RE: Response to Information Request for material change of use for a new Dwelling house within the Mixed use (inner city) zone upon land at 550 Boundary Street, Spring Hill QLD 4000, formally described as Lot 10 on RP10397 (Council ref: A007058715)

We write in relation to the development application over the abovementioned site (Council ref: A007058715) and provide the following response to Council's information request correspondence, dated 25 March 2026, under section 13.2 of the *Development Assessment Rules*.

Figure 1 – Comparison between previously proposed and revised primary facade

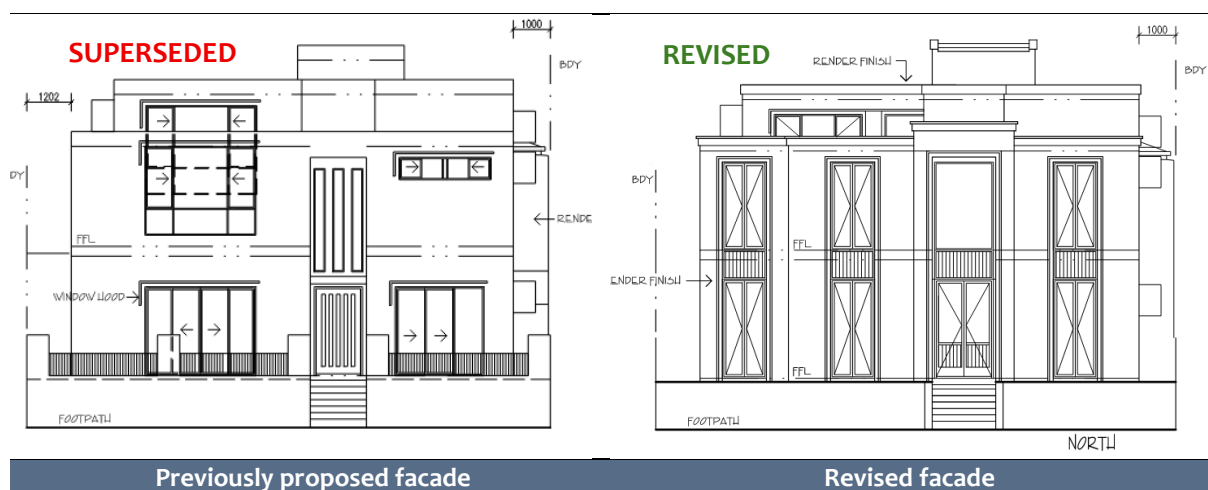
4. *The proposed front facade of the dwelling house is not considered to reflect the traditional character of the two heritage dwellings adjoining the subject site to the east and west as required in AO34.1/PO34 of the Centre or mixed use code.*
- a. *Provide amended plans and elevations in accordance with Centre or mixed use code (AO34.1/PO34) that respect and reflect the traditional frontages and facades using traditional materials and finishes.*

In response to Council's comments, the Boundary Street façade has been redesigned to provide a stronger architectural relationship with the traditional character of Spring Hill and the adjoining heritage dwellings.

The revised façade adopts an Art Deco-inspired architectural treatment, drawing upon the proportions, detailing, materials and finishes associated with this recognised early twentieth-century architectural style. This approach is considered particularly appropriate within Spring Hill, which contains examples of Art Deco architecture within the surrounding locality. Examples of nearby Art Deco buildings are provided below to demonstrate that the revised architectural language has an established historical basis within the local area.

A comparison of between the previously proposed and revised primary façade is provided in Figure 1 below.

The revised design is consistent with AO34.1, which requires development to respect and reflect the architectural theme, traditional frontages, façades, architectural qualities and traditional materials of buildings within the area, whilst expressly recognising that new development does not necessarily need to imitate historical architectural styles.

The redesigned Boundary Street elevation provides a more articulated and traditionally proportioned façade, together with architectural detailing and a material palette reflective of the Art Deco style. The dwelling also retains a low-rise two-storey domestic scale, ensuring that it does

not visually overwhelm or detract from the adjoining heritage dwellings.

Accordingly, the amended façade provides a considered contemporary interpretation of an established architectural style within Spring Hill. The revised design appropriately responds to the character of the adjoining heritage dwellings and broader streetscape whilst remaining clearly identifiable as contemporary development.
